Technical News 159
October 2014
Strictly Confidential

Contents		
Item	Description	Model Affected
Item 1.	Piston and Piston Top Ring	Daytona 675 from VIN 564948, Daytona 675 with ABS from VIN 564948 and Daytona 675 R with ABS from VIN 564948

Description: Piston and Piston Top Ring

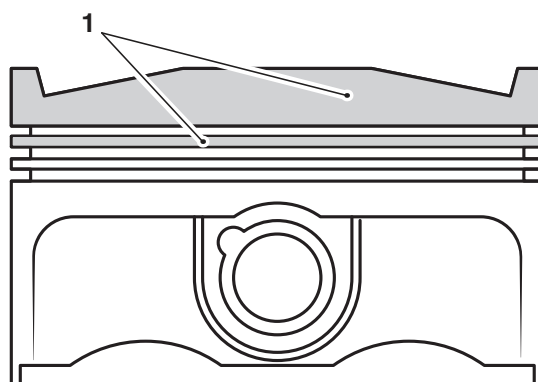
A new piston and piston top ring has been introduced to the above models from engine number 678753 and is retrofittable. When fitting a new piston, ensure the latest condition of the piston top ring is fitted to the anodised piston.

The latest condition piston has its crown anodised down to the start of the groove for the second piston ring.

The anodised area of the piston can be identified by its grey colour, as shown in the illustration below.

Do not fit the original condition top ring to the new condition piston, only fit the latest condition top ring.

The latest condition piston top ring is silver in colour and the markings on the ring are the same as the original top ring.

Do not fit the new condition top ring to an original condition piston.

Description: Alternator Rotor Retaining Bolt

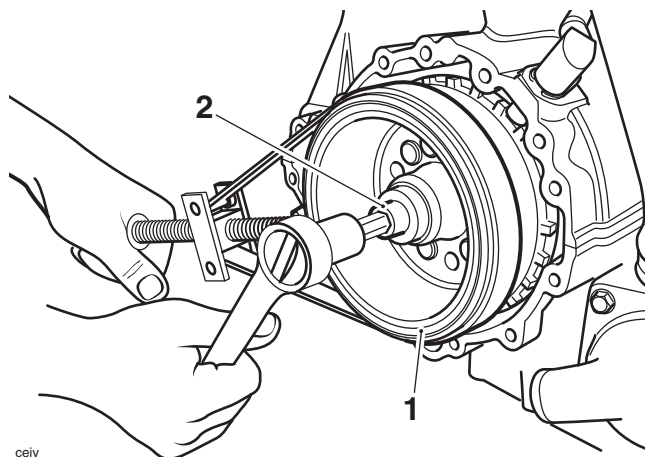
The torque figure for the alternator rotor retaining bolt has changed to **120 Nm** on the above models.

- **Models already in service need not be retightened unless the bolt has been loosened or removed.**

Description: Rear Brake Hose Guide

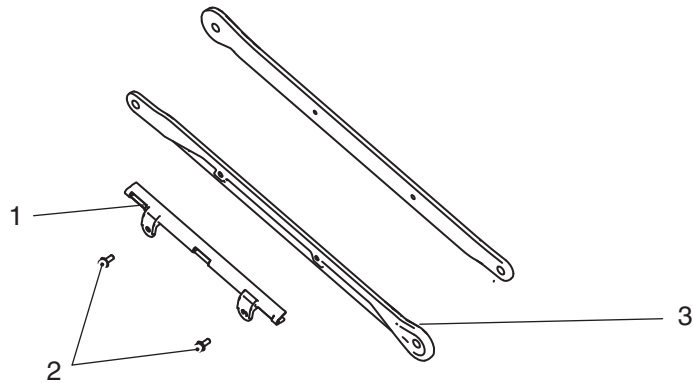
New fixings securing the rear brake hose guide to the rear suspension torque arm have been introduced on the above models from VIN 675015 and are retrofittable.

The torque figure for these fixings has also changed as shown in the table below.

Application	Torque (Nm)	Notes
Rear brake hose guide	3

Description: Auxiliary Lights

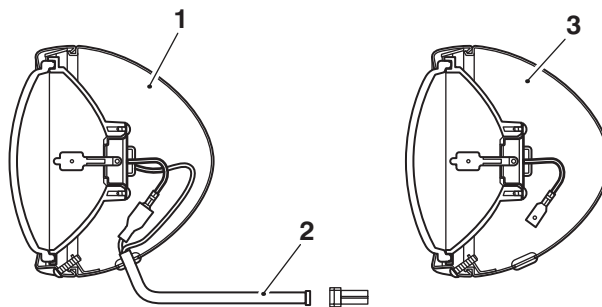
New auxiliary lights, auxiliary light sub harness and light bar have been introduced to the above model from VIN 674509. The auxiliary lights and auxiliary light sub harness are not retrofittable. The light bar is retrofittable.

The new condition auxiliary light has a fly lead fitted as shown below.

Gear Selector Drum from Engine Number 644217

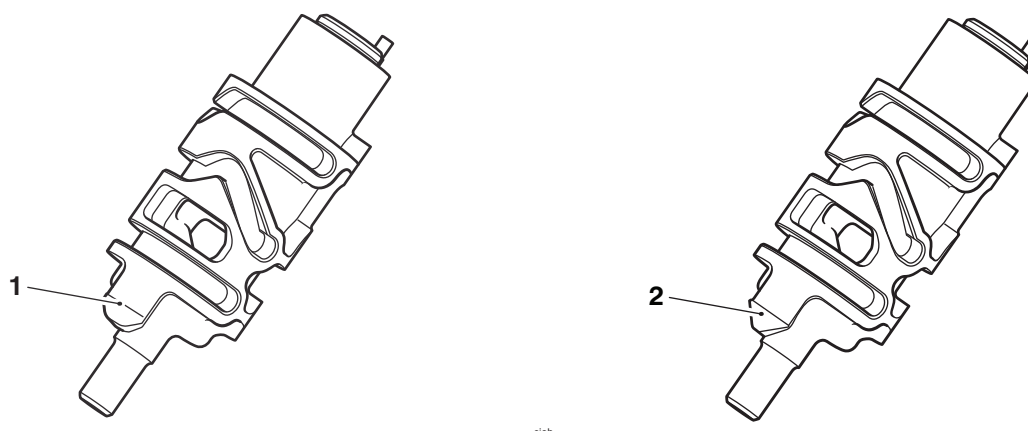
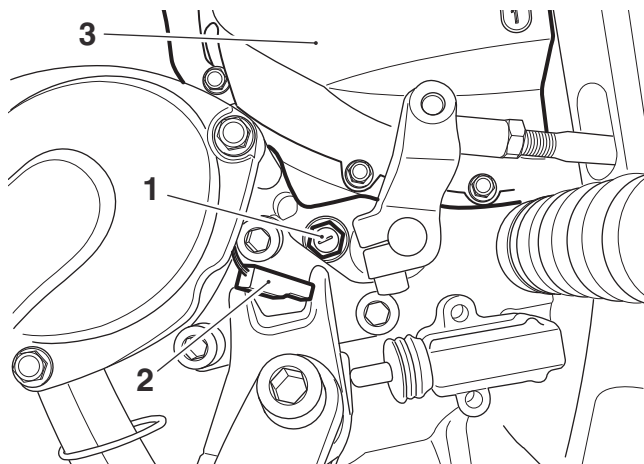
A new gear selector drum has been introduced to the following 1050 engines from engine number 644217 built at factory 5 and from engine number 665820 for engines built at factory 2:

The difference between the original condition and the new condition selector drum is the neutral switch feature as shown in the illustration below.

1. Neutral switch feature (original condition)
2. Neutral switch feature (new condition)

The new condition gear selector drum can be fitted to earlier models down to engine number 536522 but a new washer must be fitted to the neutral light switch at the same time. To facilitate this a parts kit (part number T1192233) is available.

Description: Pulser Ring Fixings

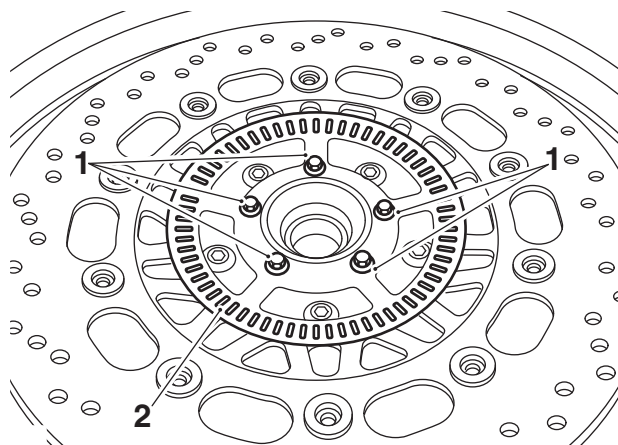
A revised fixing securing the rear pulser ring to the brake disc has been introduced on the above models from VIN 670040. The revised fixing is longer in length and is retrofittable to earlier models.

1. Tighten the pulser ring fixings to **5 Nm**.

Description: Side Stand Fixing

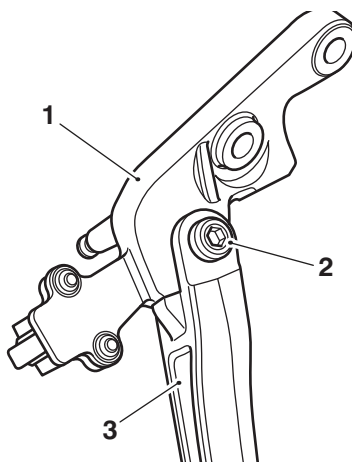
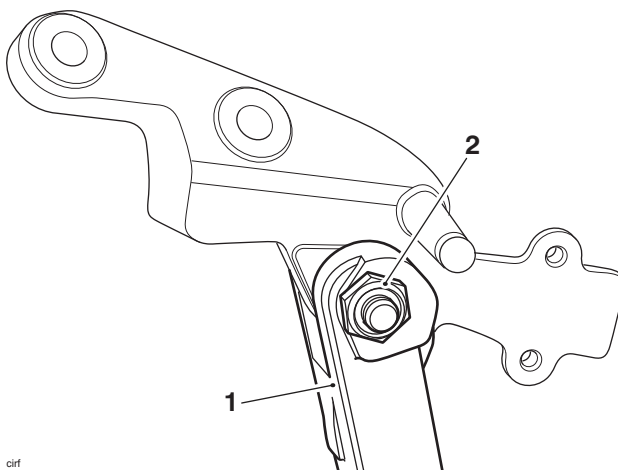
A tightening sequence to secure the side stand to the side stand bracket has been introduced on the above models.

1. Tighten the side stand bolt to **20 Nm**.

2. Whilst ensuring the bolt does not turn, tighten the lock nut to **9 Nm**.

Description: Side Stand Fixing

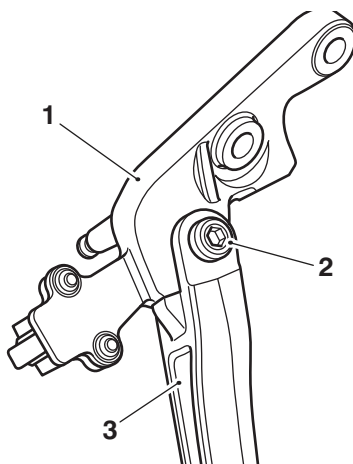
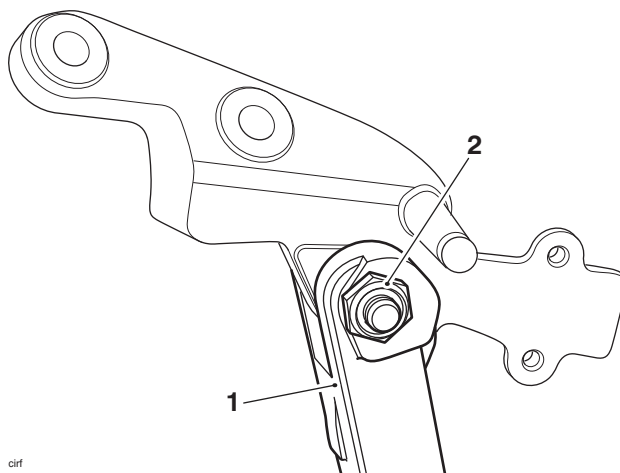
A revised bolt has been introduced on the above models from VIN 670390. If removed or replaced for any reason tighten the bolt and lock nut as described below.

1. Tighten the side stand bolt to **20 Nm**.

2. Whilst ensuring the bolt does not turn, tighten the lock nut to **9 Nm**.

Description: Battery Terminal Cover

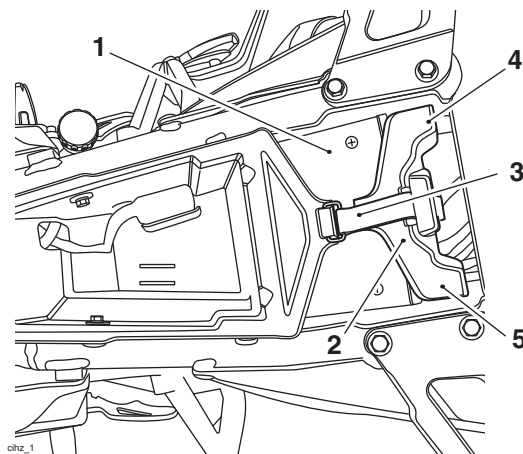
From VIN 668084, the battery terminal cover for the above model has been placed into the fixing kit for transit in the packing crate.

When fitting the battery, collect the battery terminal cover from the fixing kit, feed the battery strap through it, position over the battery terminals and secure with the battery strap, as shown in the illustration below.

Description: Heated Grip Fixings

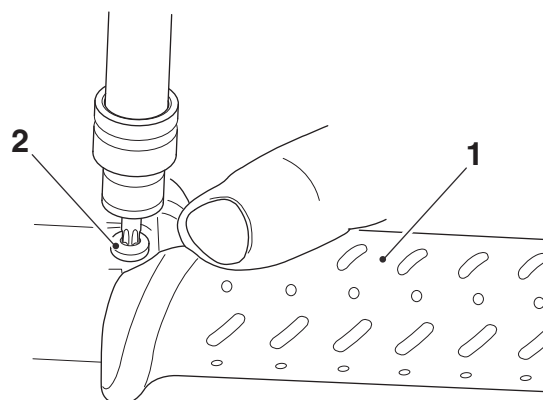
The torque figures for the bar end weights and the retaining screws on the left hand heated grip have changed and are listed in the table below:

Application	Torque (Nm)	Notes
Left hand heated grip retaining screw	3	
Handlebar end weights	5	Use new fixings

Description: Front and Rear Direction Indicator Fixings

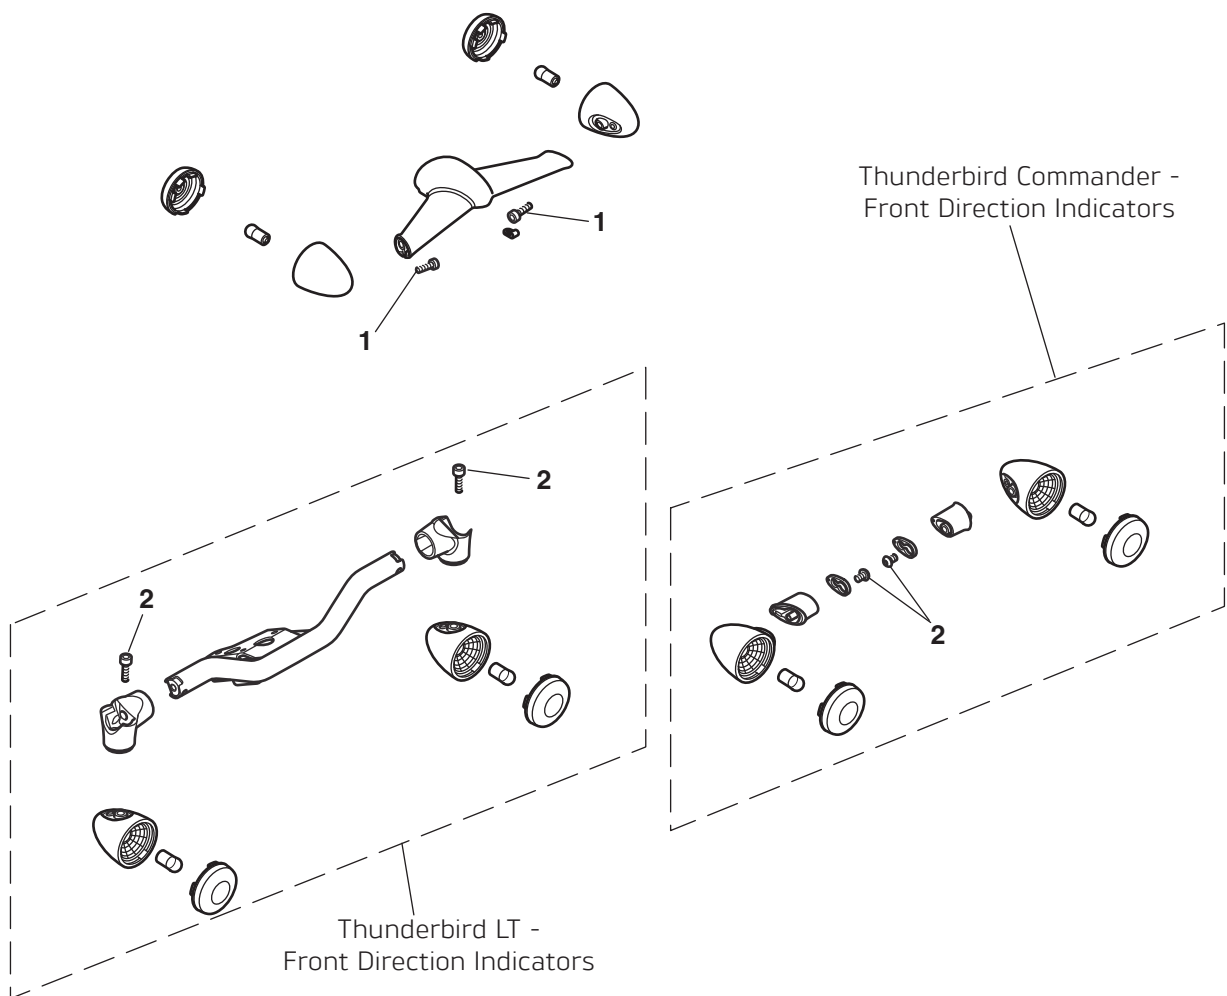
The fixings for the front and rear direction indicators have changed to encapsulated fixings on the above models.

The torque figure for these fixings is **18 Nm**, as described in the Service Manual. These fixings must be replaced if they are loosened or removed.

Description: Clutch Lifter Piece

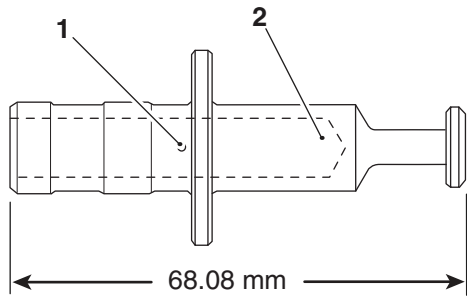
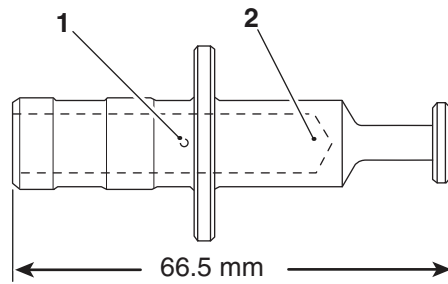
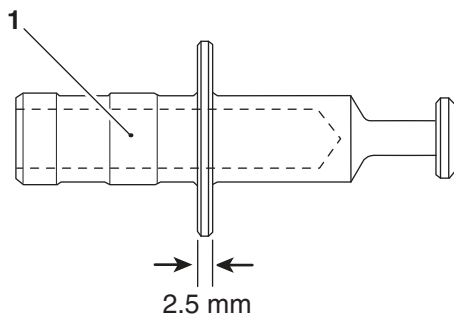
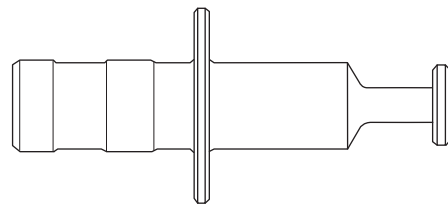
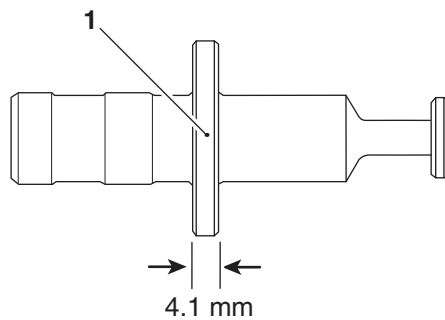
From the start of production the clutch lifter piece, on the above models, has had several changes. The purpose of this Technical News item is to show when the changes were made, what the changes were and how to identify the relevant clutch lifter piece.

Part Number/Issue Level	Engine Number	Changes/Comments
Lifter Piece T1170029 issue 1	Start of production	Washer T3550234 required
Lifter Piece T1170029 issue 2	-	Length of lifter reduced from 68.08 to 66.5 mm, Washer T3550234 required
Lifter Piece T1170057 issue 1	249179	Oil drilling removed, shoulder width reduced from 3 to 2.5 mm, Washer T3550234 required
Lifter Piece T1170057 issue 2	280804	Centre drilling removed, Washer T3550234 required
Lifter Piece T1170059 issue 1	300855	Part number change only, Washer T3550234 required
Lifter Piece T1170059 issue 2	369112	Shoulder width increased to 4.1 mm, Washer T3550234 removed
Lifter Piece T1170159 issue 1	369112	Part number change only, Washer T3550234 not required
Lifter Piece T1172023 issue 1	635897	Part number change only, Washer T3550234 not required

The clutch lifter that was introduced at engine number 635897 (part number T1172023) is retrofittable back to engine number 249179.

When fitting the latest condition clutch lifter piece to an older engine which has a lifter piece, flat washer and a wave washer, discard the flat washer and fit the new lifter piece with the wave washer only.

When fitting the latest condition clutch lifter piece to an older engine which has a lifter piece and a wave washer, fit the new lifter piece with the wave washer.

Description: Rear Brake Caliper Bleed Nipple

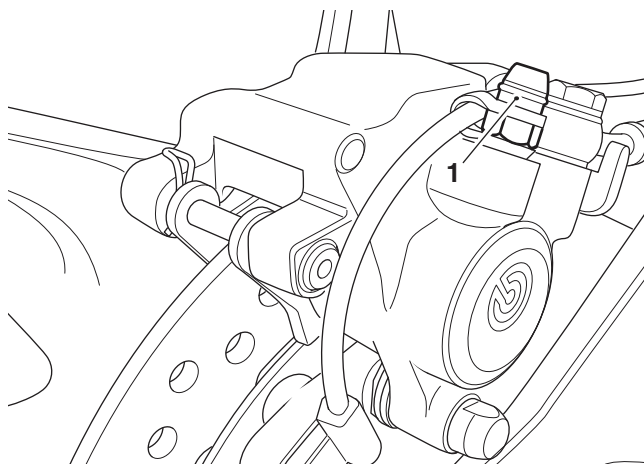
The torque figure for the rear brake caliper bleed nipple described in the Service Manual is incorrect, for the above models. The correct torque figure is **14 Nm**.
